# Amendment of the Site Certificate for the Carty Generating Station

Subject: Technical Comments, NWCMTF 3 of 4

## Technical Comments to PGE Carty Station Site Certificate Amendment

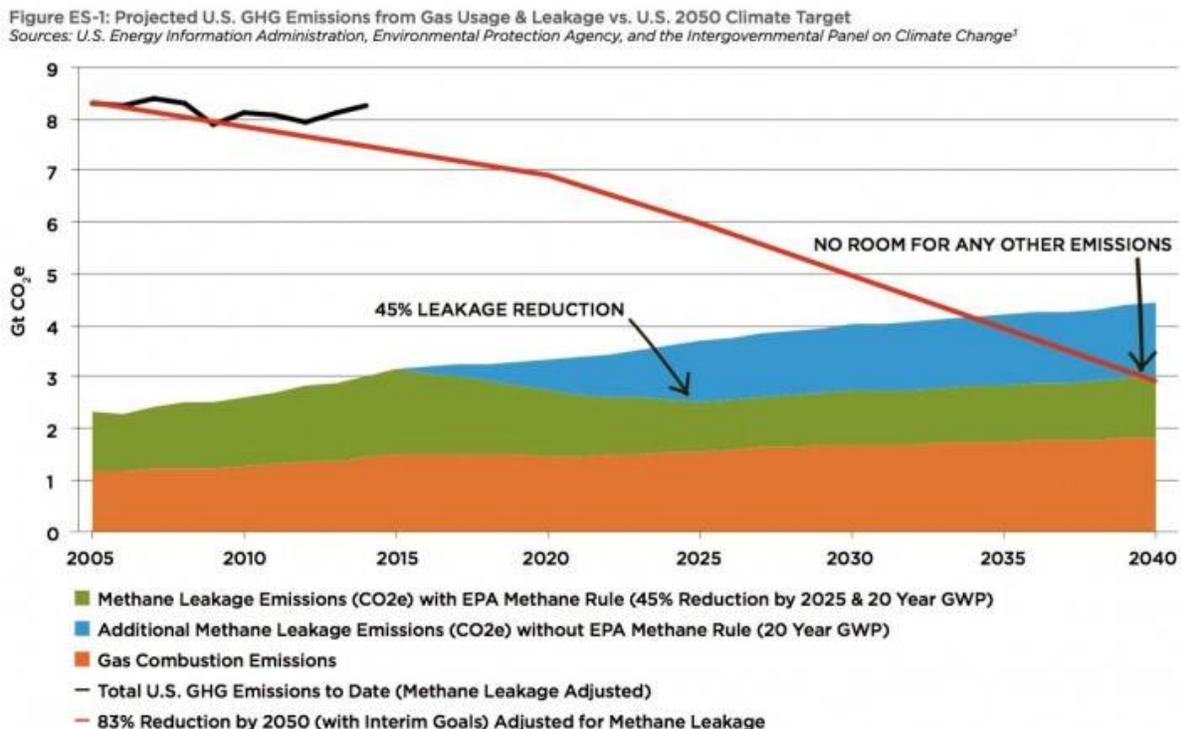
Another difficulty with the report is the absence of GHG trends plotted against a planned upper bound for emissions that leads to climate success in 2050. Examples of such a graphic exist. For example, natural gas emissions are predicted in Figure ES-1 in the report, “A BRIDGE TOO FAR: HOW APPALACHIAN BASIN GAS PIPELINE EXPANSION WILL UNDERMINE U.S. CLIMATE GOALS”. Ref

For convenience this figure is provided below, and it is further captioned in Figure 8 in the reference report. Actuals, goals and fuel predictions are integrated in the same graphic.
